§ 10.5 UNLIMITED 5 figures for 2024

Version 2 Corrected 2023-10-14

GAC Comments and ranking

G TOTAL K=126

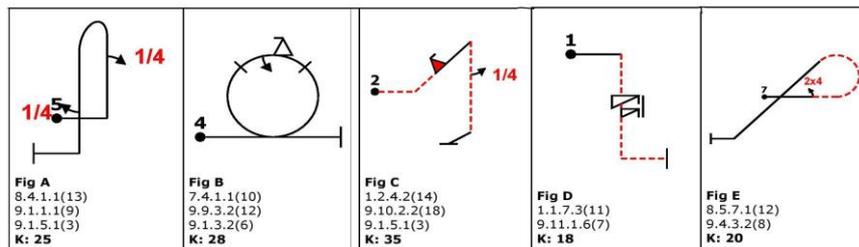
GAC	Rank	COMMENTS
Pekka Havbrandt	1	
Ferenc Toth	No	
Jerzy Makula	2	
Madelyne Delcroix		
Eugen Schaal	2	
Philippe Küchler	1	Proposal G: flyable with Fox and SZD

D TOTAL K=120

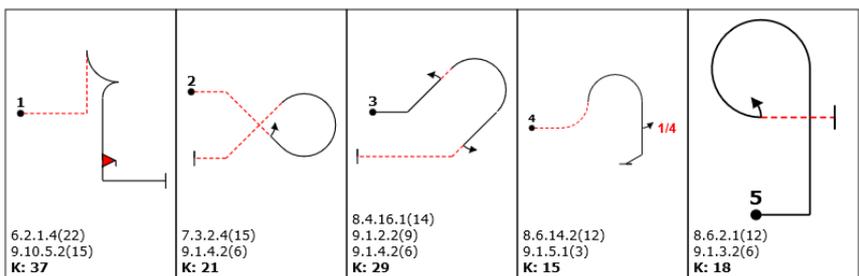
GAC	Rank	COMMENTS
Pekka Havbrandt	2	
Ferenc Toth	3	
Jerzy Makula	3	
Madelyne Delcroix		
Eugen Schaal	3	
Philippe Küchler	4	Proposal D: flyable with Fox and SZD

F TOTAL K=124

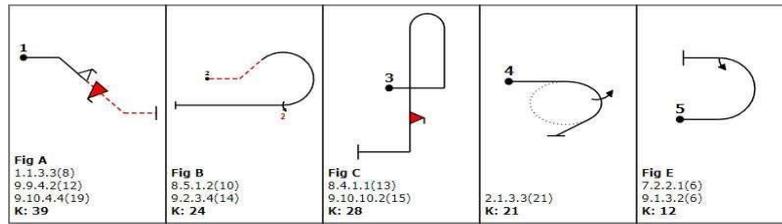
GAC	Rank	COMMENTS
Pekka Havbrandt	No	Too much entry speed for second snap.
Ferenc Toth	4	
Jerzy Makula	4	
Madelyne Delcroix		
Eugen Schaal	1	
Philippe Küchler	2	Proposal F: flyable with Fox and SZD

E TOTAL K=118

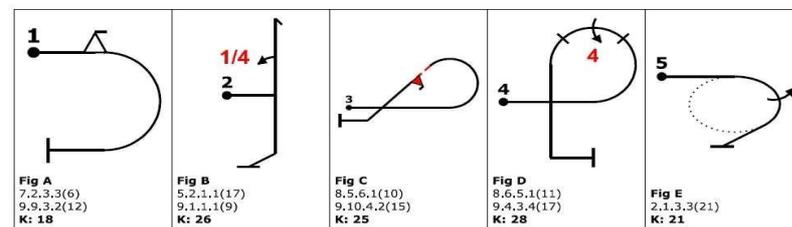
GAC	Rank	COMMENTS
Pekka Havbrandt	3	
Ferenc Toth	No	
Jerzy Makula	1	
Madelyne Delcroix		
Eugen Schaal		
Philippe Küchler	3	Proposal E: flyable with Fox and SZD

A TOTAL K=122

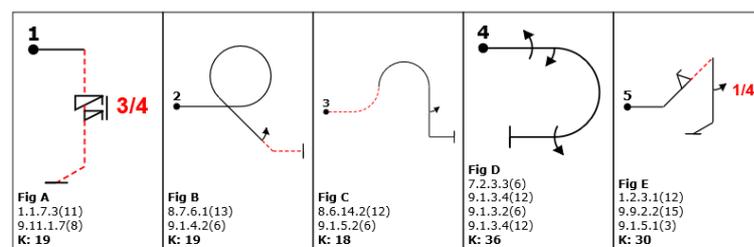
GAC	Rank	COMMENTS
Pekka Havbrandt	No	Fig B critical in regards of Vne for Acro59. OK for Fox
Ferenc Toth	No	
Jerzy Makula	No	
Madelyne Delcroix		
Eugen Schaal	No	Fig. B and C critical Vne with Fox and SZD. Fig. C out of range for SZD
Philippe Küchler	No	Proposal A: NOT recommended Fig. B and C critical in regards of Vne for the Acro59.

B TOTAL K=122

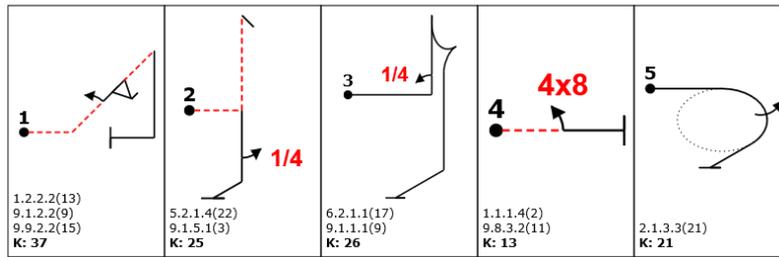
GAC	Rank	COMMENTS
Pekka Havbrandt	No	For Acro 59. Fig. A close or at Vne in the entry
Ferenc Toth	2	
Jerzy Makula	No	
Madelyne Delcroix		
Eugen Schaal	No	Fig A critical (Va, aileron, and Vne) for Fox and SZD
Philippe K�uchler	No	Proposal B: NOT recommended For Acro 59 Fig. A close or at Vne in the entry

C TOTAL K=124

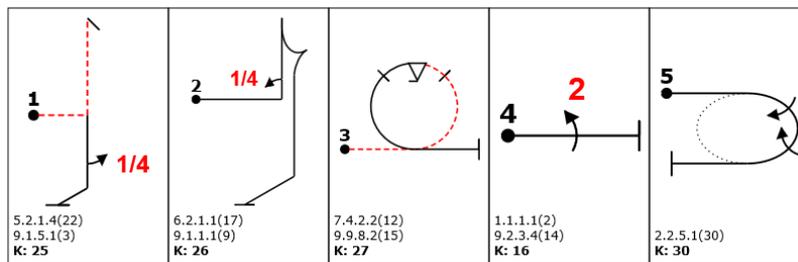
GAC	Rank	COMMENTS
Pekka Havbrandt	No	Acro 59 limit on Fig. C. Maybe possible.
Ferenc Toth	1	
Jerzy Makula	No	
Madelyne Delcroix		
Eugen Schaal	No	Fig C close to limit for SZD59
Philippe K�uchler	No	Proposal C: NOT recommended flyable with Fox, SZD limit on Fig. C

H TOTAL K=118

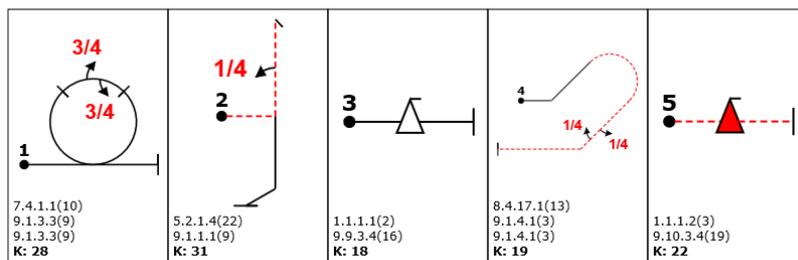
GAC	Rank	COMMENTS
Pekka Havbrandt	No	For Acro59. Not enough aileron command to make 1,5 rolls on top. Fig D Vne problem.
Ferenc Toth	No	
Jerzy Makula	6	
Madelyne Delcroix		
Eugen Schaal	No	Fig. B close to limit for SZD59 (Vne). Fig. D close to, or above limit (Vne) for Fox and SZD59
Philippe K�uchler	No	Proposal H: NOT recommended Fox: Fig. D close or at Vne on the downline SZD: Fig. B to E limit or very difficult, but ok, Fig. D same as for the Fox

I TOTAL K=118

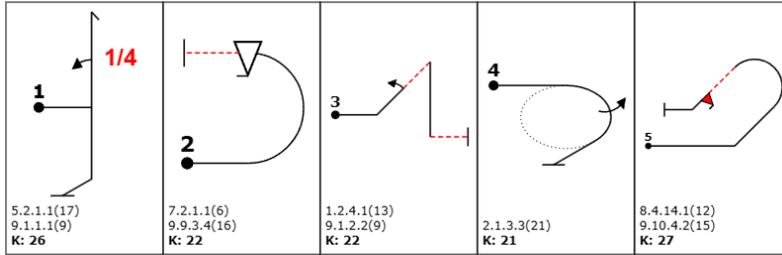
GAC	Rank	COMMENTS
Pekka Havbrandt	No	For Acro59. Energy problem with Fig B. No speed after snap.
Ferenc Toth	No	
Jerzy Makula	5	
Madelyne Delcroix		
Eugen Schaal	No	Fig B unsuitable for SZD59, won't fly any more after snap. Ok for Fox
Philippe Küchler	No	Proposal I: flyable with Fox SZD: Fig. B limit

J TOTAL K=117

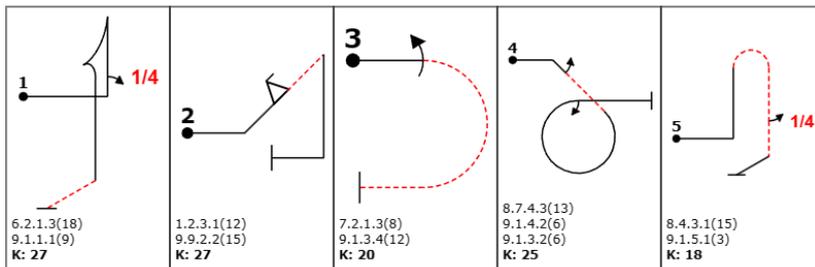
GAC	Rank	COMMENTS
Pekka Havbrandt	No	SZD: Fig. C and D at Vne and operating limits
Ferenc Toth	No	
Jerzy Makula	No	
Madelyne Delcroix		
Eugen Schaal	No	Fig J is just dangerous for SZD and Fox (Vne or very high G at bottom of the loop. Fig C close to Vne
Philippe Küchler	No	Proposal J: NOT recommended Fox: Fig. D close or at Vne and operating limits on the downline SZD: Fig. C and D at Vne and operating limits
